Stormwater Management Plan
Grasswood Estates W1/2 26-35-5W3
R.M. of Corman Park, Saskatchewan

File S1607.4

Subject: Response to Shawn Dukart - Community Planning Branch

Subject: Response to Saskatchewan Watershed Authority Conceptual Stormwater
Management Plan, Grasswood Estates, W1/2 26-35-5 W3 Dated May 28, 2012

TITLE
STORMWATER MANAGEMENT PLAN
EXISTING GROUND vs. MINIMUM BUILDING
ELEVATION COMPARISON

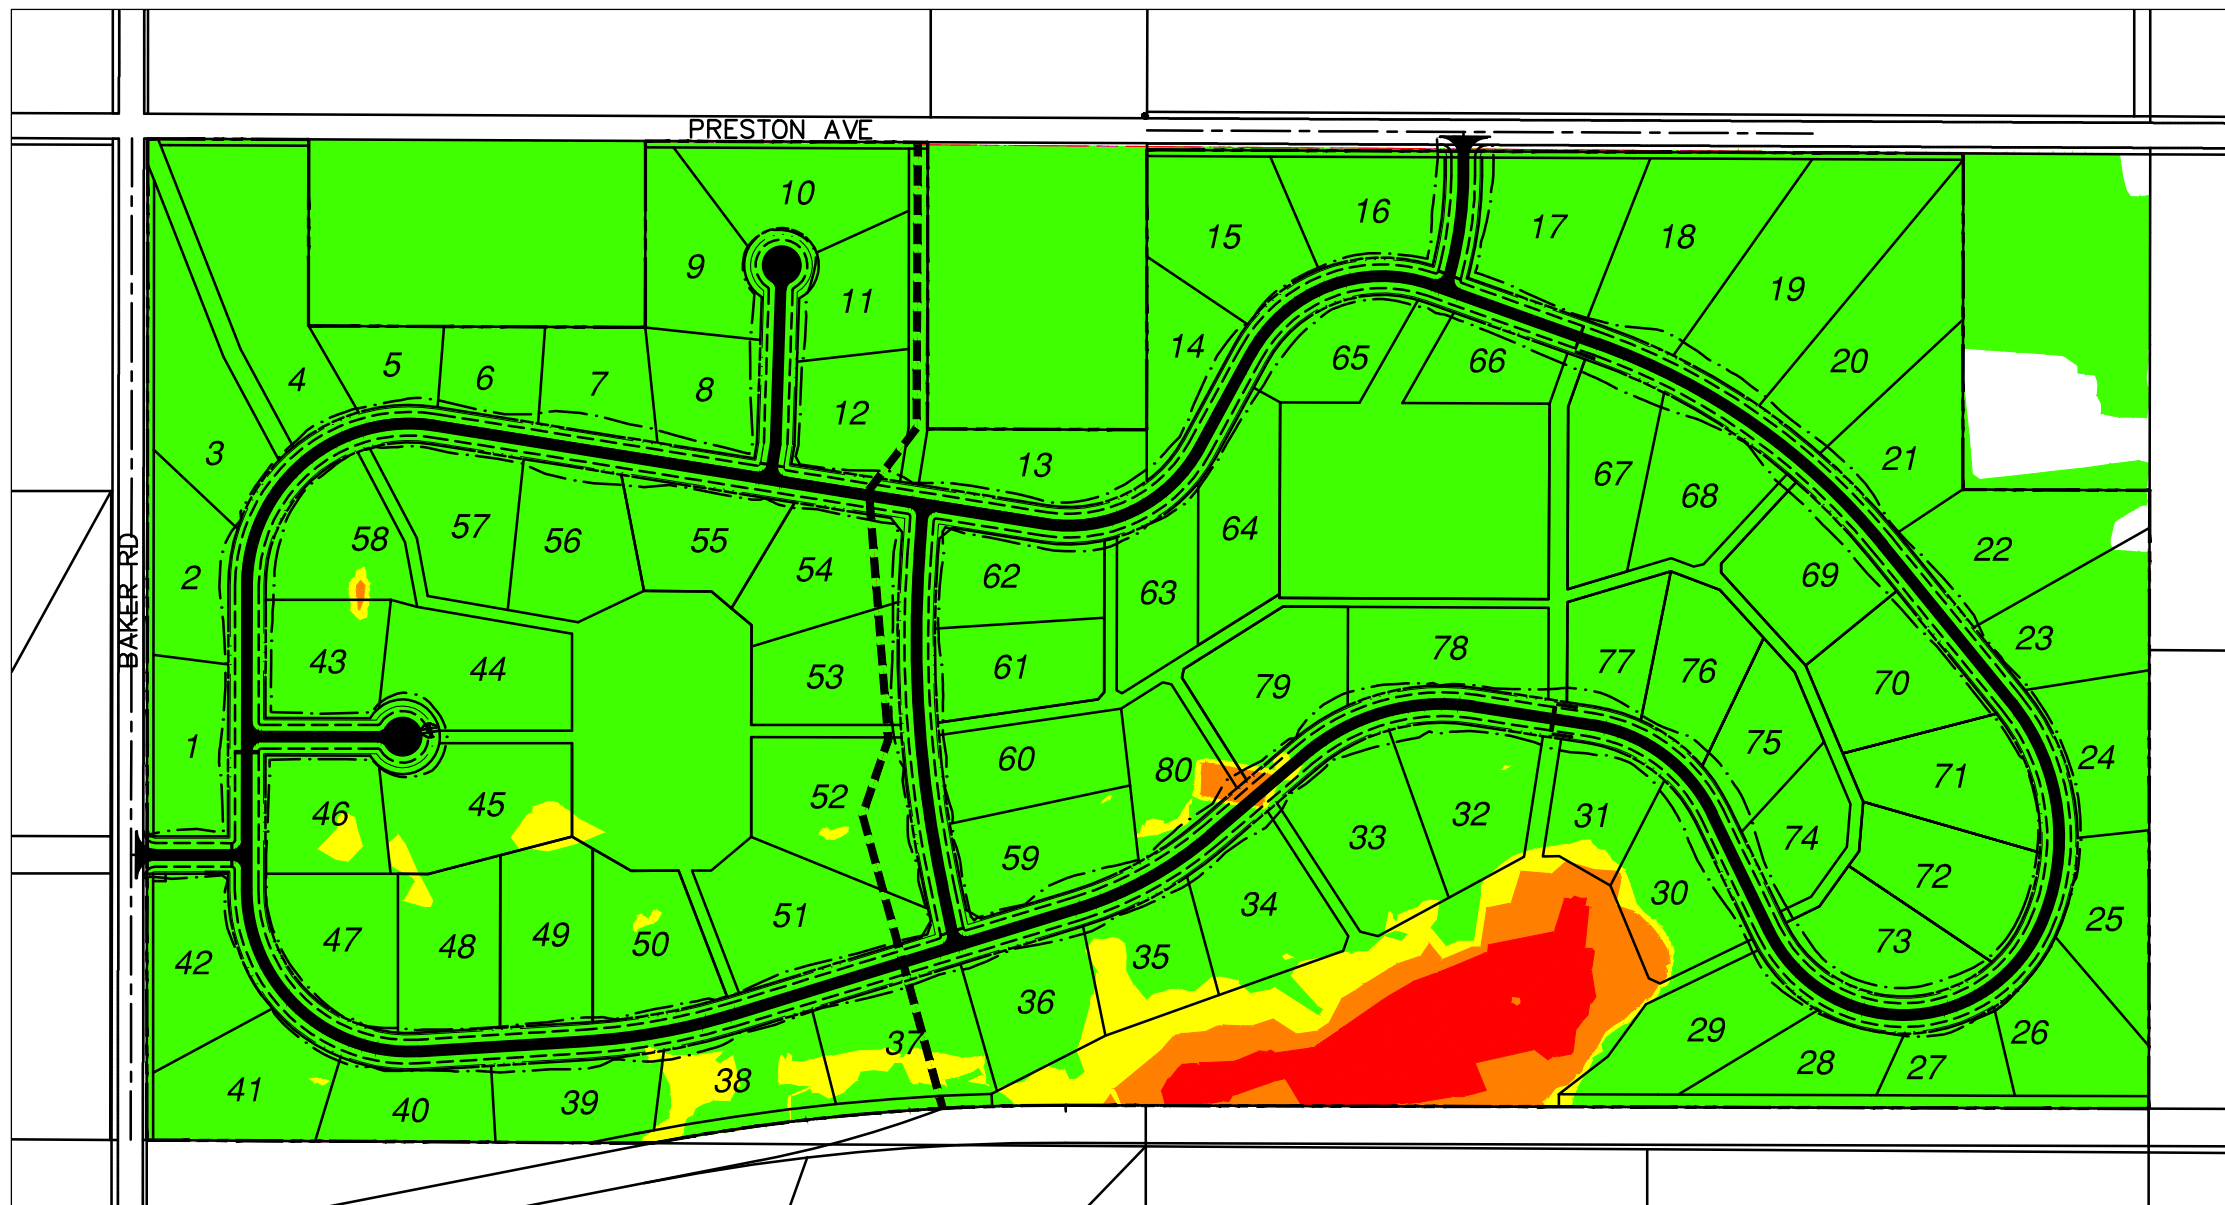
4) It's unclear how the elevation of 509.5 m was determined as the safe building elevation, I don't feel that there is sufficient information contained in the report to comment on the appropriateness of this value. A map with contours and coloured digital elevations is also included.

The original design utilized a cumulative model to determine the maximum water elevations and for comparison purposes, a 1:500 year event was analysed as well. Additionally, we reviewed the whole site in comparison to this minimum building elevation, and the majority of the site is higher than this level. Please see Drawing S1607.8-004 attached. The colours represent the following relation:

- The Green represents areas where existing ground is higher than minimum building elevation;
- The Yellow represents areas where existing ground is lower than minimum building elevation by less than 1.0 metre;
- The Orange represents areas where existing ground is between 1.0 metres to 2.0 metres lower than minimum building elevation; and,
- The Red represents areas where existing ground is 2.0 metres or more lower than minimum building elevation.

It is worth noting that each pond's minimum finished floor elevation was compared to existing ground within each pond's catchment area. Based on this, we believe that the minimum building elevations can be achieved for most lots without significant earth work on the majority of the Site. The lots that have significant depressions (i.e. over 1m in depth) can be identified and recommendations for building permanent structures can be provided if required, however this level of detail is beyond the scope of this report.

Attachments: Drawing S1607.4-002 Conceptual Drainage System

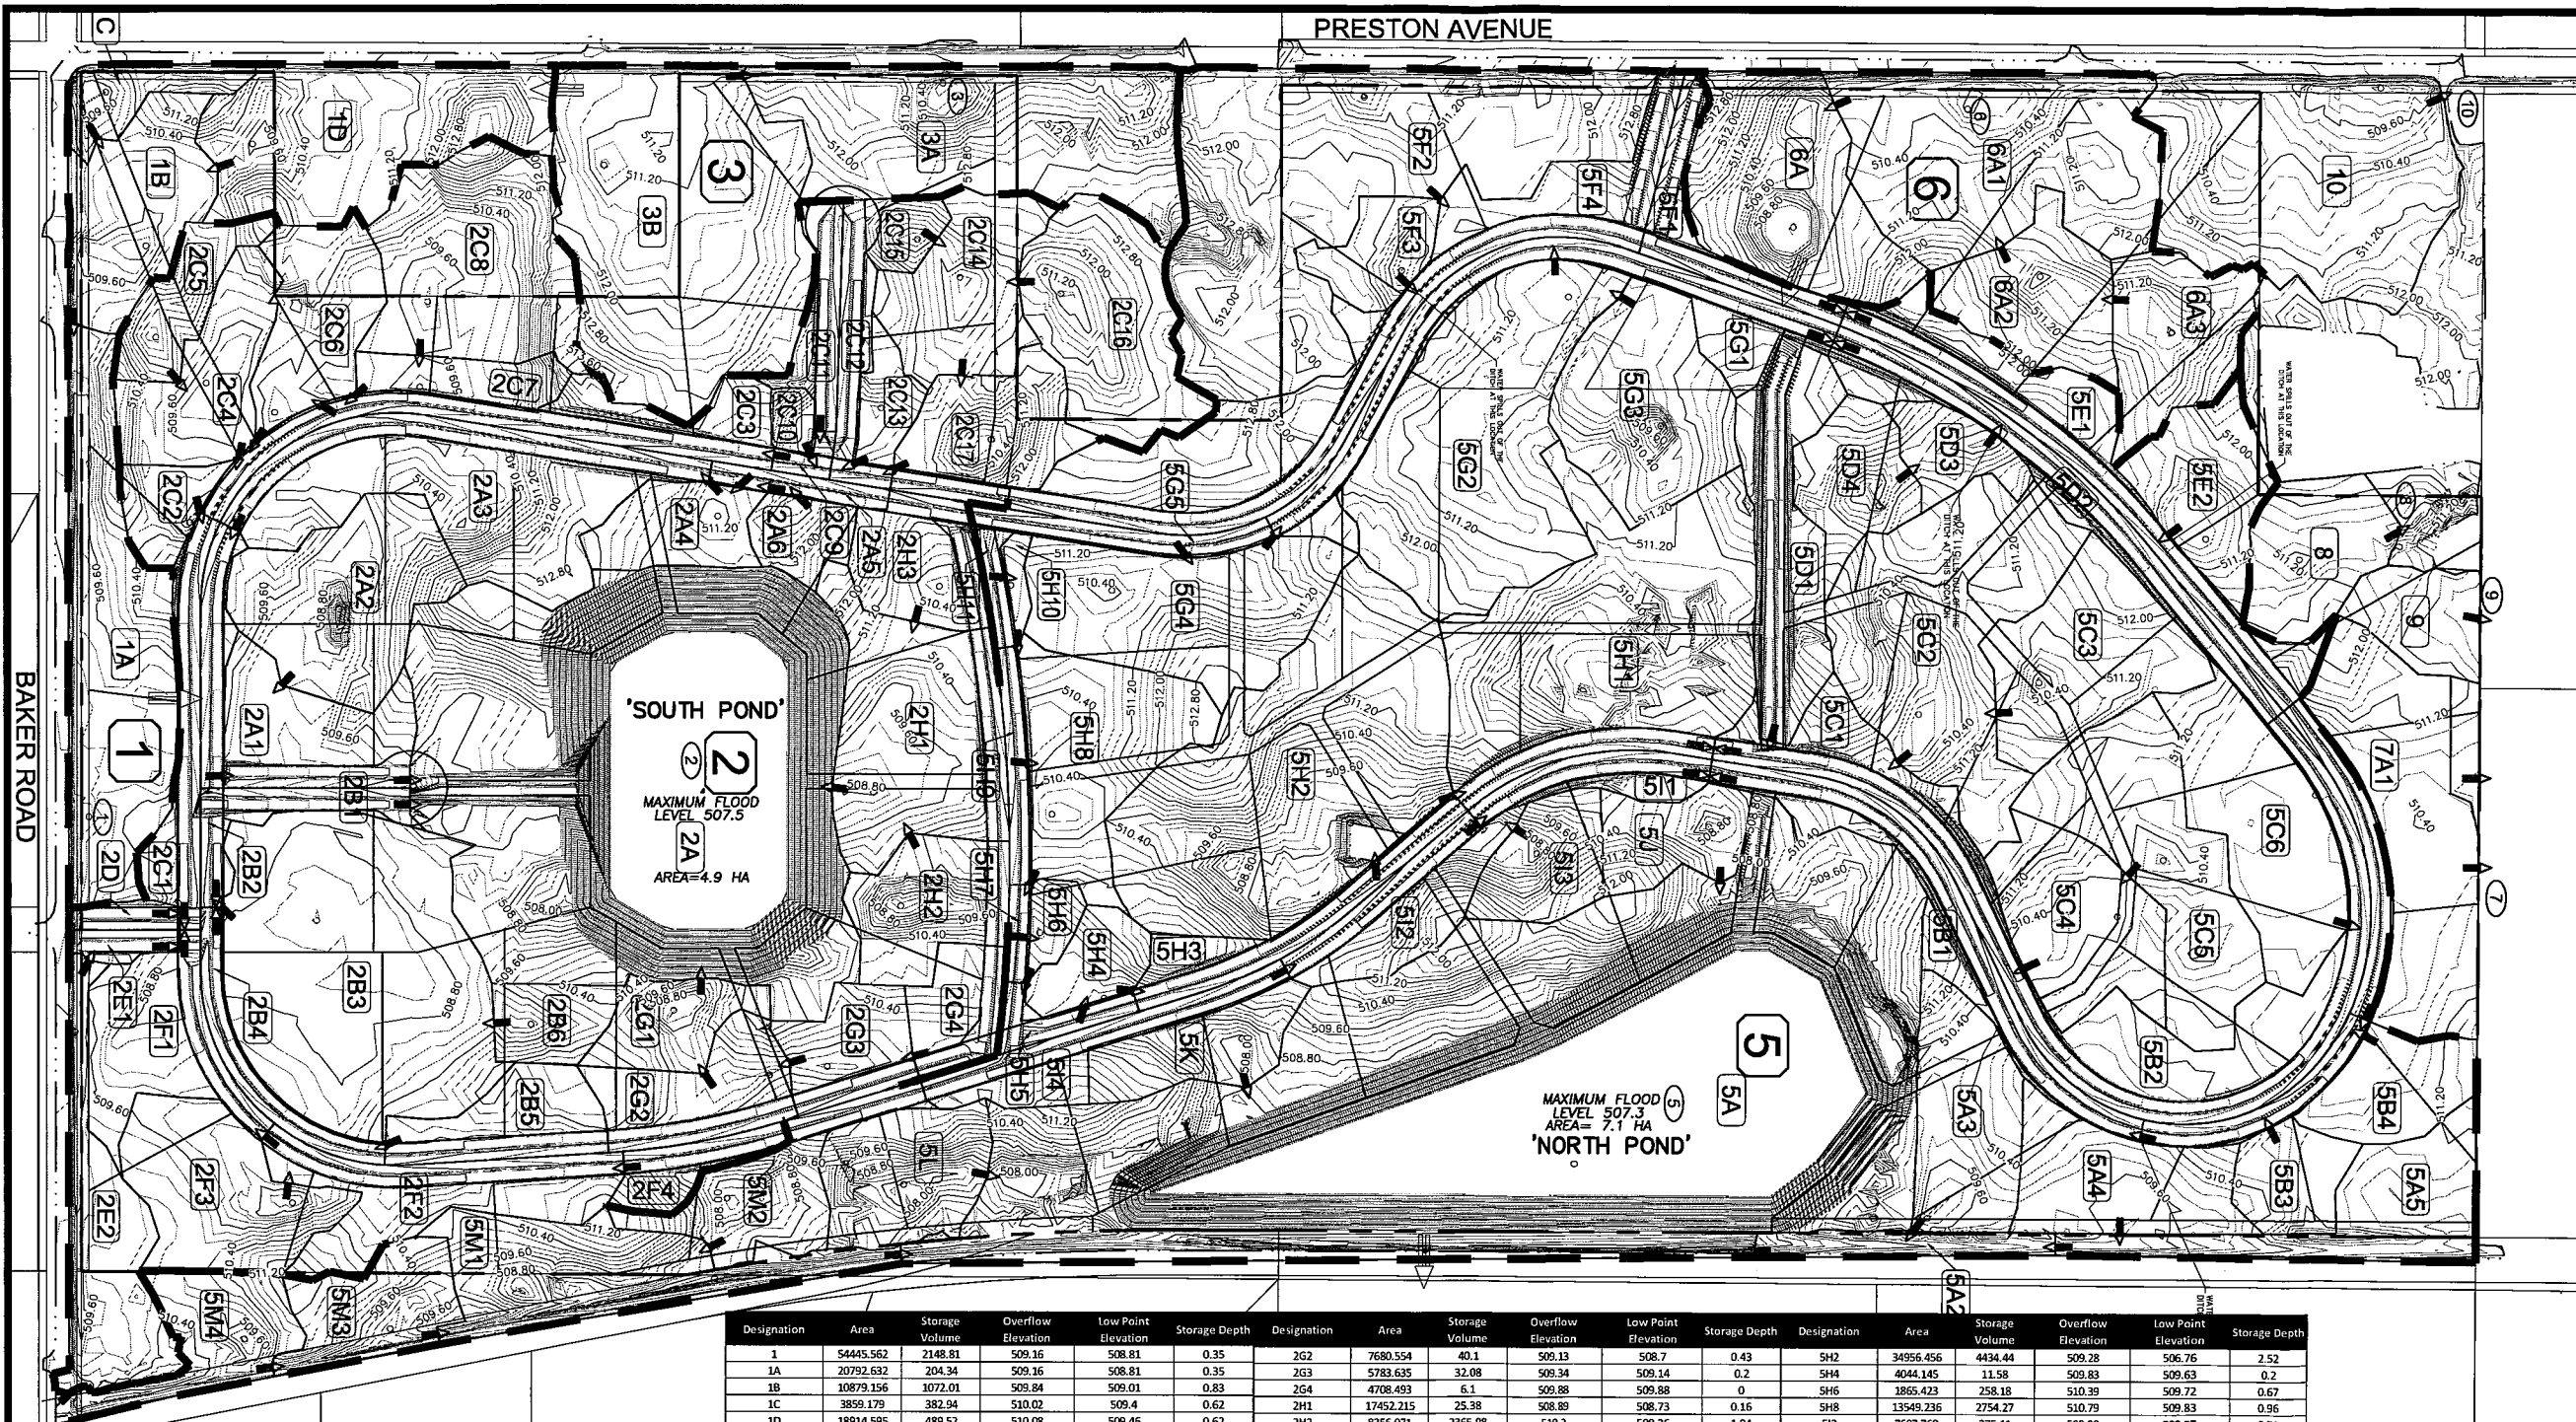
We provided additional analysis of the 1:100 year storm event plus 25% as recommended in an email dated 7 June 2012 from Rebecca Row with the R.M. of Corman Park. An excerpt from the email is included below:

The main concern we have is the stormwater plan utilizing the backs of private properties to pond water. We will be asking Council to discuss this option, but Planning will likely not be supporting it.By utilizing private property we are in the opinion that the stormwater management plan has not been designed to effectively manage a 1:100 (plus 25% b/c of no outlet) storm event. We had made a comment regarding utilizing public lands in our first round of comments (#5 under Storm).

1. A new PPS showing both ponds and the High Water marks for the 1:100 and 1:500 levels. These levels will determine which lots require flood easements. There also seems to be some issue with the elevations on the original plans; the SBE is said to be 509.5m while the contours indicate elevations in the 483-490m range, please advise.

The additional analysis was conducted in response to this statement to compare our methodology to the 1:100 year storm event and 25% methodology it was conducted in accordance with the City of Saskatoon New Neighbourhood Design and Development Standards Manual, Section Six dated January 2012. This analysis was completed using the rational method utilizing a 1:100 year event based on the recommended developed conditions runoff coefficient, and 24 hour storm duration. The water surface elevation (WSE) that was generated based on this approach is indicated in green on the north pond on the attached Drawing S1607.4-002.

Results of this analysis indicated that the flood elevation of this event was significantly lower than the flood elevation that was recommended in our report which is indicated on the outer black line labeled Maximum WSE 507.3 (see attached drawing). The difference in flood elevations on the north pond is more than 6.5 m when compared.

Please note that the 1:100 year cumulative event plus 25% WSE shown in red is based on net volumes calculated throughout a 51 year period, and is provided to further demonstrate the conservative approach of our design methodology. The difference in flood elevations are approximately 3.5 m on both ponds using this comparison.

Response: The subdivision plan and corresponding topographical data that was originally presented to SWA has been superseded and has updated spatial data. Please find updated plan S1607.4-02 attached to this letter.

TYPICAL NORTH POND SECTION
NOT TO SCALE

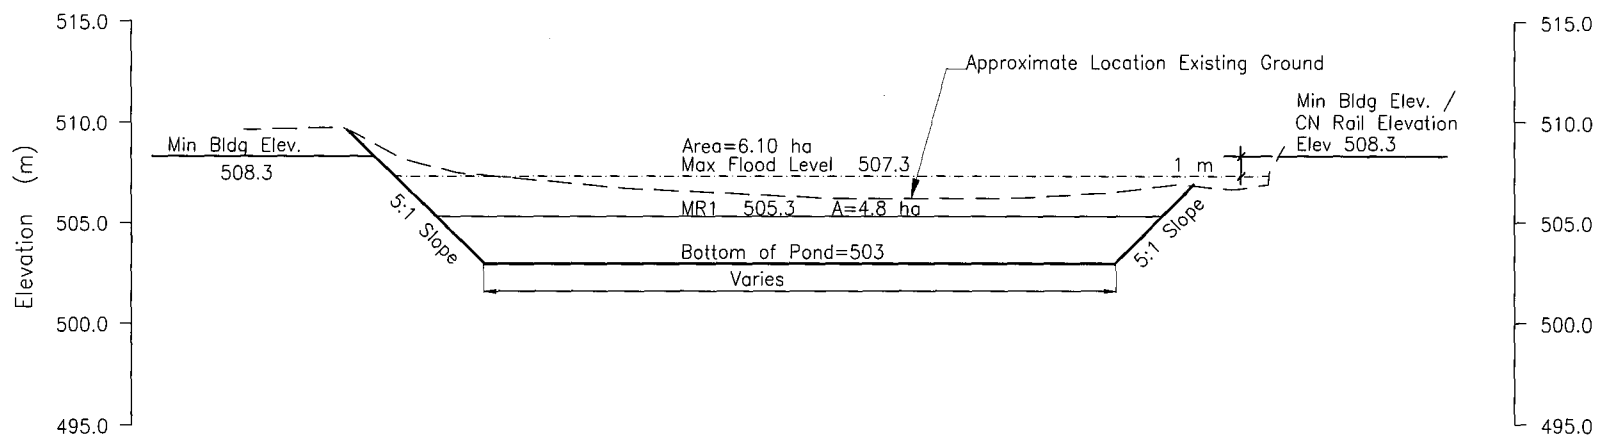
2. SWA will require copies of all flood easements once they are determined and signed.

- c) The following North and South Pond figures will be revised: S1697.4-002, S1697.4-003 and S1697.4-004 to include the updated pond bottom elevation of 503.0.

Response: We understand that the owner of the property can provide easements as they are approved. To clarify where these will be required, the lots begin at the municipal reserve boundary at contour 505.3 (north pond), 505.5 (south pond) and end at the maximum flood level at contour 507.3 (north pond) and 507.5 (south pond). Each pond cross section is attached for your reference, namely Drawing No. S1607.4-003, and S1607.4-004 respectively.
